**DRAFT DESIGN REPORT**  
*FOR*  
**BURKE CREEK HIGHWAY 50 CROSSING AND  
REALIGNMENT PROJECT, PHASE I**  
*STATELINE, NEVADA*

**March 2016**

<b>Comments on Burke Creek HWY 50 Crossing and Realignment Project</b>				
			<b>Commenter: Erik Nilssen P.E., Douglas County</b>	<b>Responder: NTC Engineering</b>
<b>Comment #</b>	<b>Document</b>	<b>Page</b>	<b>Comment</b>	<b>Response</b>
DC-1	50% Plans	ii	Douglas County will need a set of as-built plans as well.	Noted
DC-2	50% Plans	ii	Note seems like it does not apply. Plenty of work will take place outside of the NDOT ROW.	Irrelevant portion of note has been deleted
DC-3	50% Plans	G-1	"Potential Access to Upstream Work Via Existing Sierra Colina Road" needs to be clarified. Is this an access or not? Contractor needs to know for sure what they can use.	The access point from the Douglas County ball fields has been made the primary access point for upstream improvements on the 90% plans. For separate Sierra Colina mitigation work, the Contractor may choose to use the Sierra Colina access point.

1 OF 19

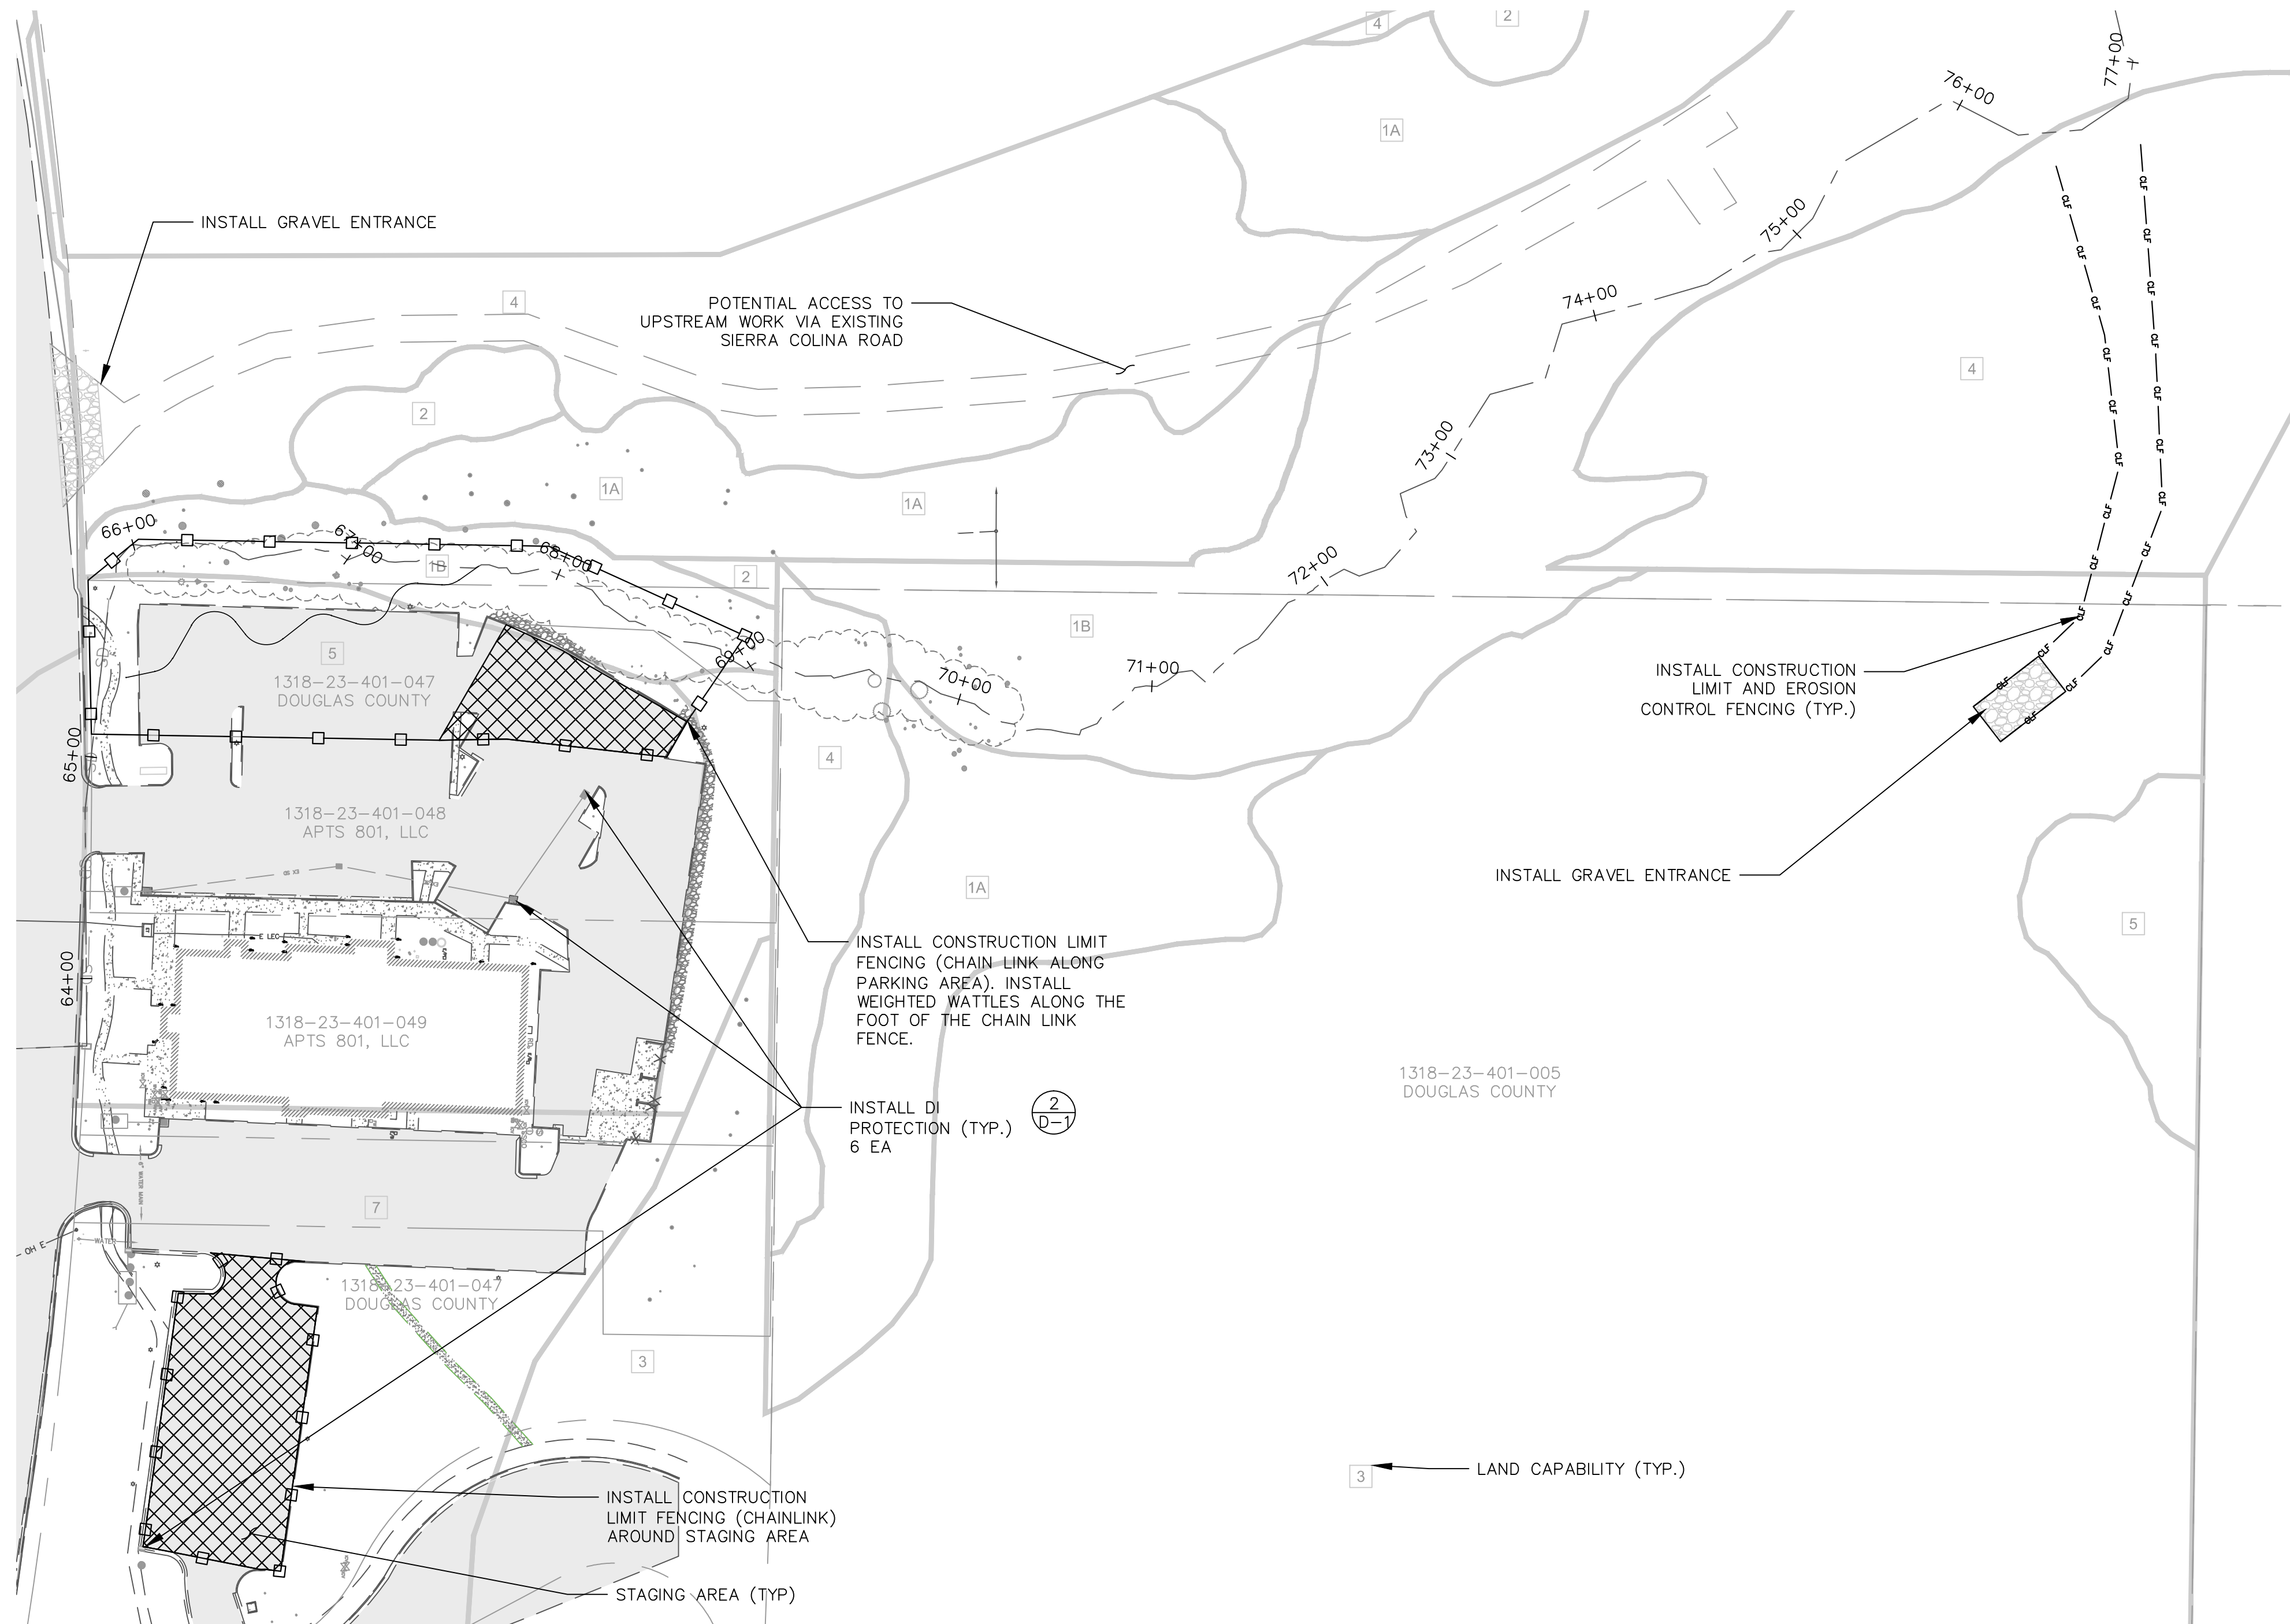
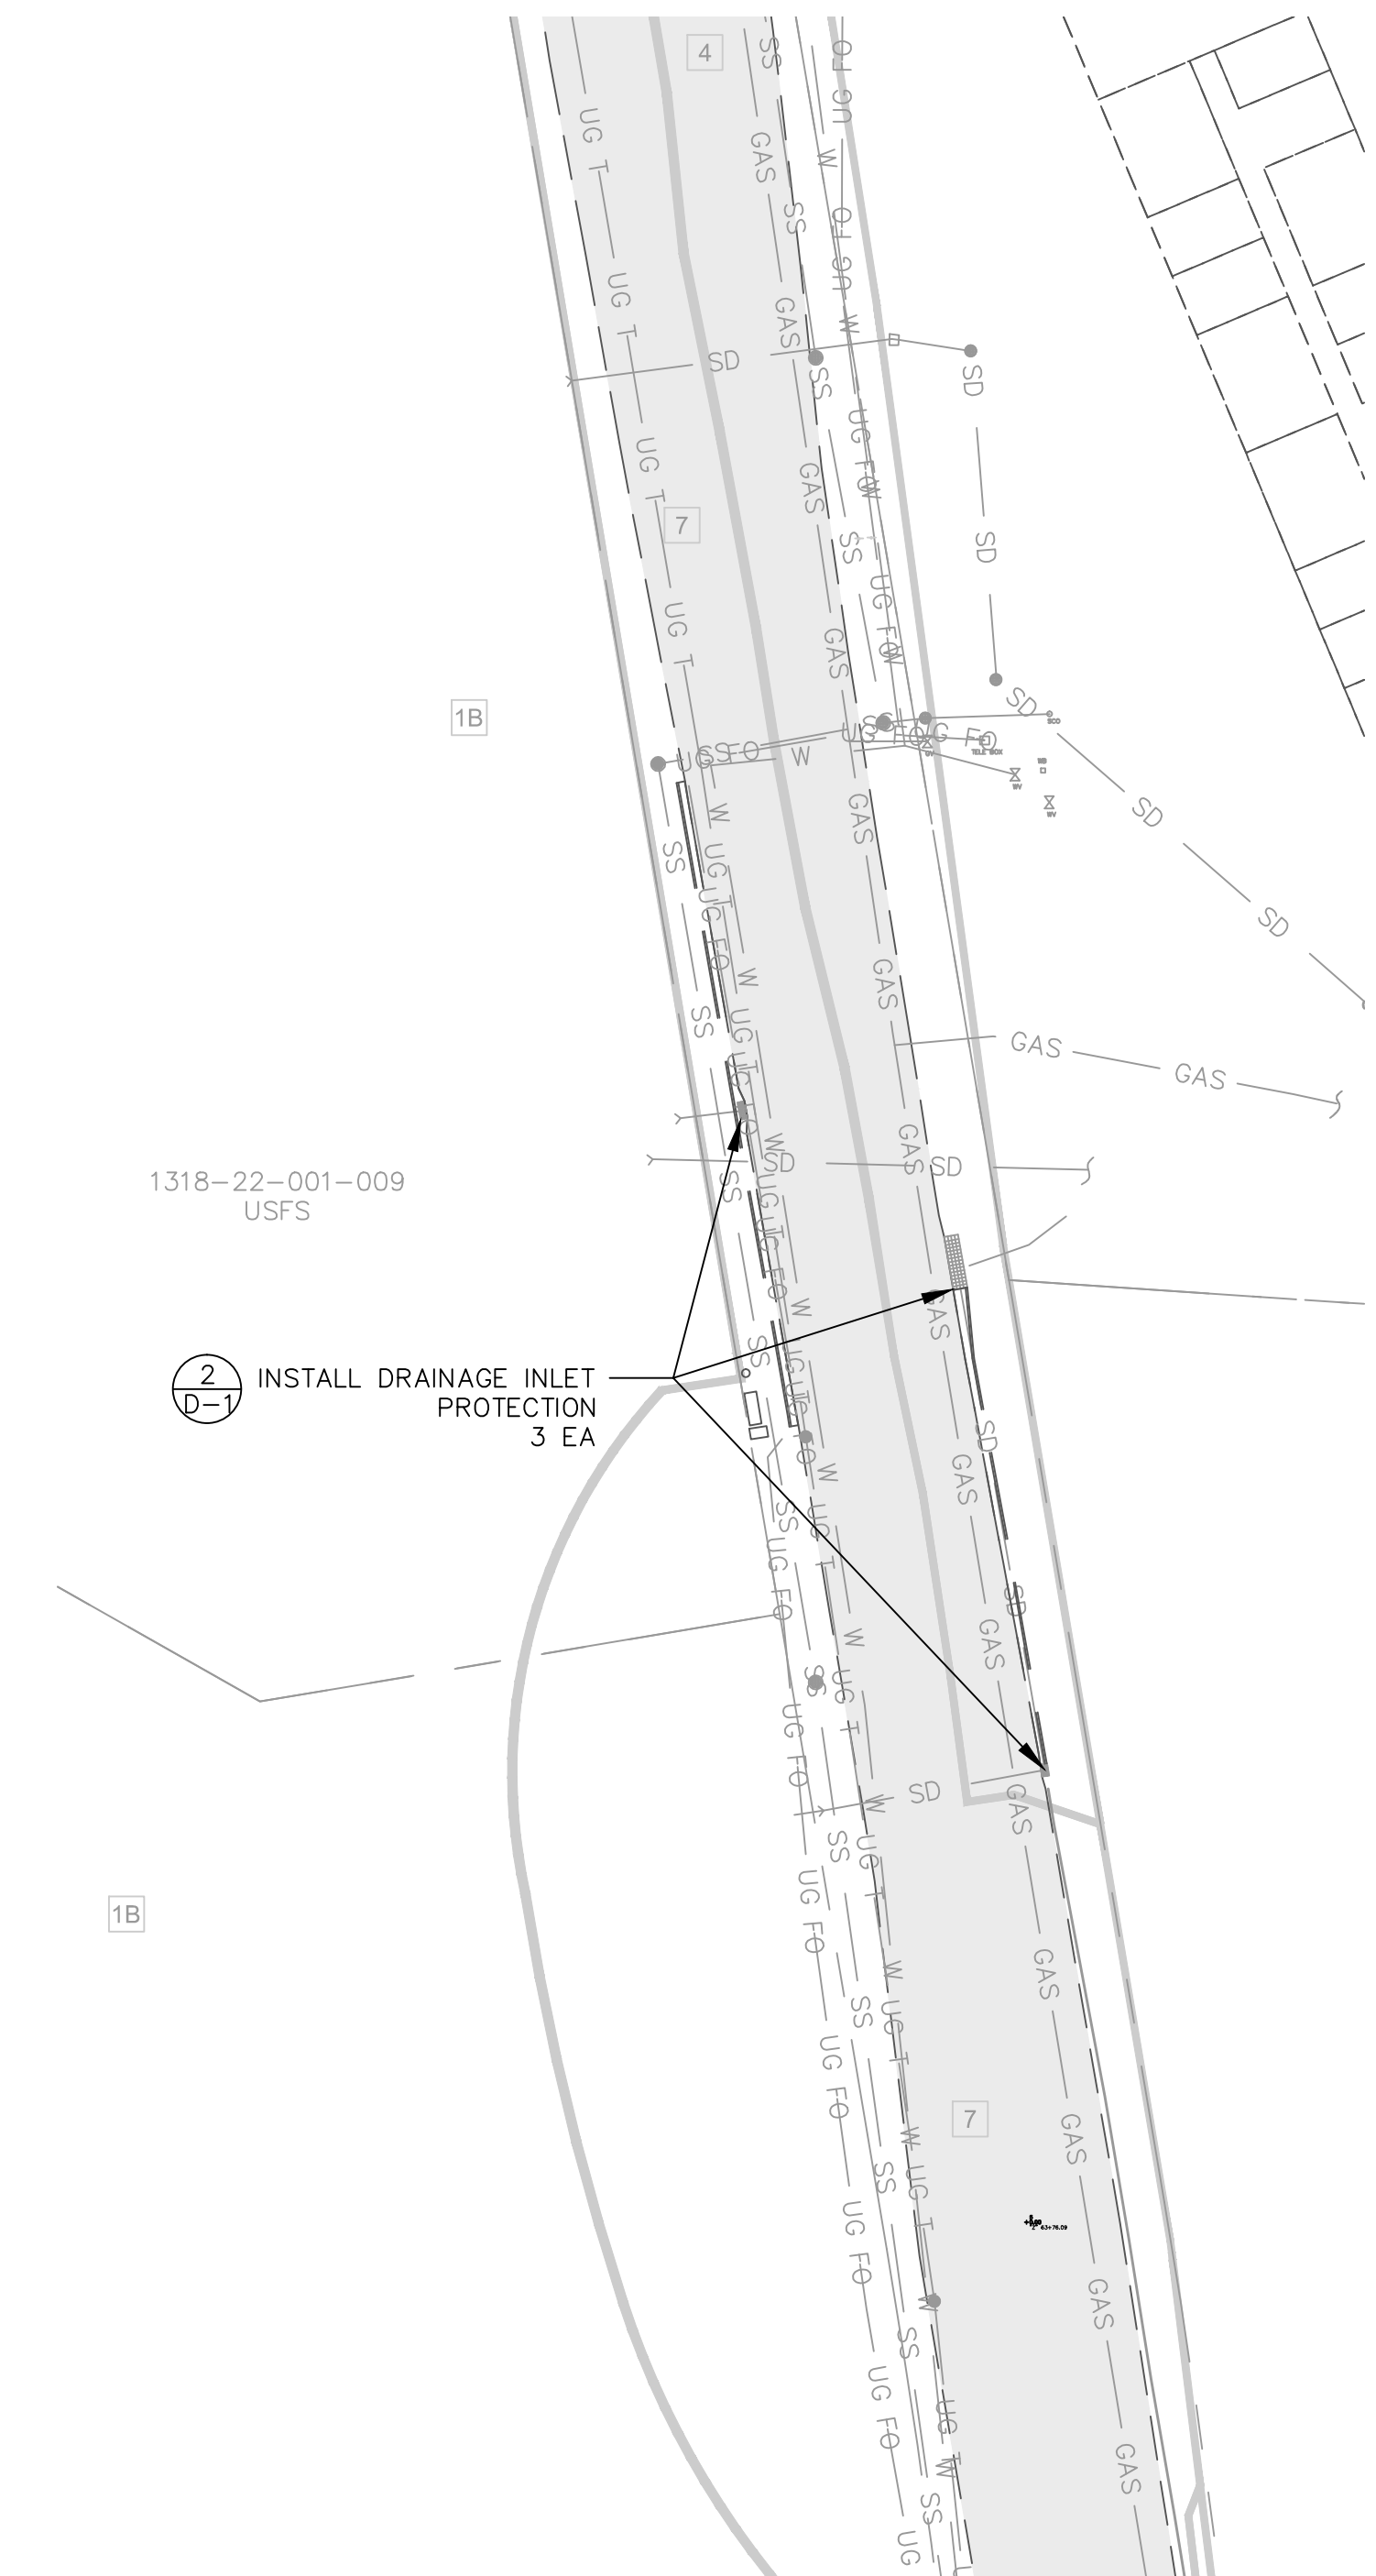
DC-4	50% Plans	G-1	Show the existing Sierra Colina Fence. Maybe it can function as the construction fence in-lieu of the chain link fence. Not sure about putting chain link across the creek.	the fence has been shown on relevant sheets. Chain link fence has been changed to CLF in appropriate locations.
DC-5	50% Plans	G-1	This page needs to reference details. Details should be provided for the chain link fence and gravel entrance.	Details for temporary erosion control have been included in the 90% plans. chain link fence and gravel entrance are detailed in the specifications. Gravel entrance detail is on Sheet D-7 of plans.
DC-6	50% Plans	G-1	Do we have the temporary construction easements to place DI protection on Van Buskirk's property?	We do not have the construction easement to protect two of the inlets shown on the 50% plans. The inlet protection at these inlets have been removed from the 90% plan set.

DC-7	50% Plans	G-1	Show all easements including the temporary construction and access easements obtained from Mr. Bluth during the BLA.	Completed on 90% plans
DC-8	50% Plans	G-1	Right side of the page "Plan--Drainage Work"--label US 50. There should be some stationing or something to locate the work. This stretch of work is not identified and could be anywhere on the 50 from Sacramento to Maryland.	Alignment and labeling has been added to general sheets.
DC-9	50% Plans	G-2	"Proposed Tree Removal" table--DBH is an acronym used that is not in the legend. I don't know what it stands for.	Diameter at Breast Height has been added to the abbreviations list.
DC-10	50% Plans	G-2	Label road as US HWY 50.	Alignment and labeling has been added to general sheets.
DC-11	50% Plans	G-2	Remove "and/or plug" from the stormdrain removal note. Doesn't make sense to leave it. Also, call out the size, material, and length of stormdrain to be removed.	Call-outs have been adjusted.
